UNITED STATES
DEPARTMENT OF THE INTERIOR
BUREAU OF LAND MANAGEMENTFORM APPROVED
OMB NO. 1004-0137
Expires: January 31, 2018**SUNDRY NOTICES AND REPORTS ON WELLS**
Do not use this form for proposals to drill or to re-enter an abandoned well. Use form 3160-3 (APD) for such proposals.5. Lease Serial No.
NMNM53936A

7. If Unit or CA/Agreement, Name and/or No.
NMNM870888. Well Name and No.
WEST BISTI COAL 11 COM F 19. API Well No.
30-045-28466-00-S110. Field and Pool or Exploratory Area
BASIN FRUITLAND COAL

Plug and Abandonment Procedure (Group B)

BLM FLUID MINERALS Geologic Report

DJR Operating, LLC
Proposed Wellbore Diagram

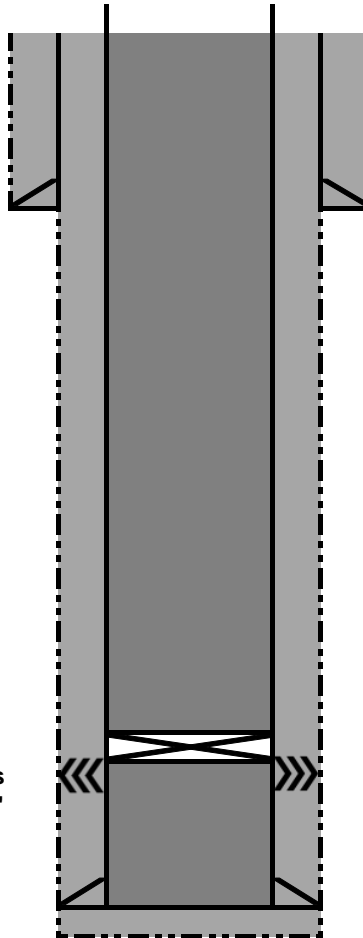
- The proposed plugging plan, if executed as presented, will adequately protect the freshwater sands in this well bore.

- Please ensure that the tops of the Pictured Cliffs and Fruitland formations as well as the entire Ojo Alamo aquifer, identified in this report, are isolated by proper placement of cement plugs. This will protect the freshwater sands in this well bore.
